PLANNING, ZONING, & BUILDING DEPARTMENT
PZ&B Staff Combination Memorandum: Architectural Commission and Town Council

SUBJECT: ARC-24-0110 (ZON-24-0068) 233 OLEANDER AVE (COMBO)

MEETING: DECEMBER 20, 2024, ARCOM
JANUARY 15, 2024, TC

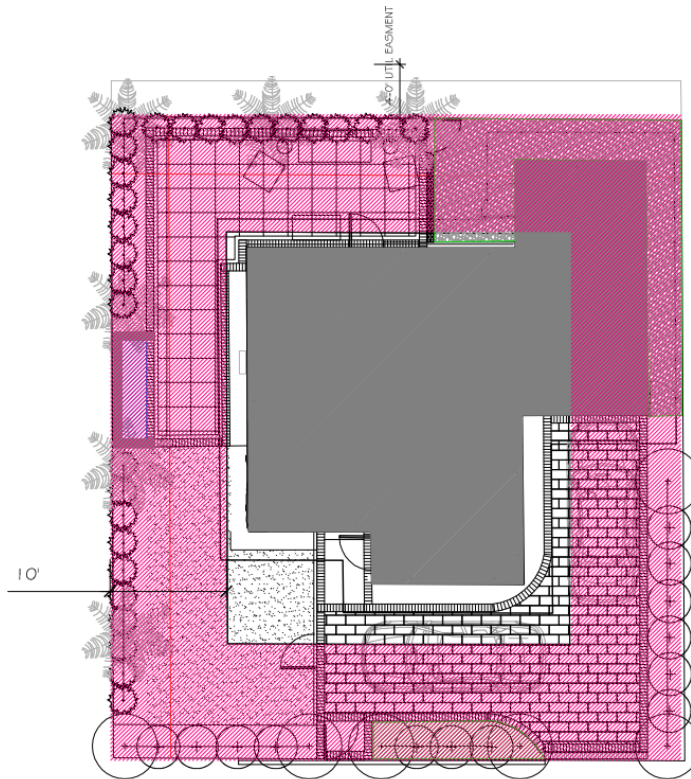
The proposal includes the removal the existing west driveway and the sodding of that general area that will be enclosed by a black chain link fence screened with pigeon plum. The east driveway will be repaved with real grass joints and feature a larger, rectangular cast stone pattern. Other proposed plant materials include five (5) pygmy date palms, one (1) oleander, six (6) clusea, six (6) Florida thatch palms in addition to pigeon plum, podocarpus, groundcovers, vines and sod. Hardscape materials presented are cast stone, pavers with grass joints, stucco, zellige tiles, and white powder coated gates.
